AMENDMENT UNDER 37 CFR §1.121 to the DRAWINGS

AMENDMENT UNDER 37 CFR §1.121 REMARKS

Resnikoff's Figure 16

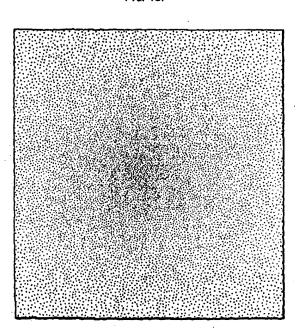
(b) Resnikoff teaches an interpolation method which generates a "high resolution array" (col. 9, line 29

places), which is illustrated in Fig. 16 (e.g. "...densely packed near the center of the array", col 10, line 35). Note, however, that their method adds pixels to the already present, randomly spaced pixels, such that their added pixels are also randomly placed, as can be seen

in Resnikoff's Fig. 16.

They add pixels to correct for their undersampling of the image (col. 4, lines 45 - 47). Close consideration of their disclosed algorithm reveals that interpolation between three randomly placed pixels will yield an interpolated pixel which is also randomly positioned relative to the other pixels (except for the 3 used to make the interpolation, of course, to which its position will be related by the calculation of the center of mass or barycenter).

However, in our Claims 9, 14, and 21, we have claimed generating a "uniformly spaced data samples" array from our non-uniformly spaced data set which would be of the same density (e.g. same number of pixels) as the non-uniformly-space data set, which yields data similar to that of standard, grid-based sensors, which makes the output compatible with standard file types (emphasis added):

We have amended Claims 9, 14, and 21 to more clearly specify this uniformly spaced output of our interpolation steps, which is not taught or suggested by Resnikoff.
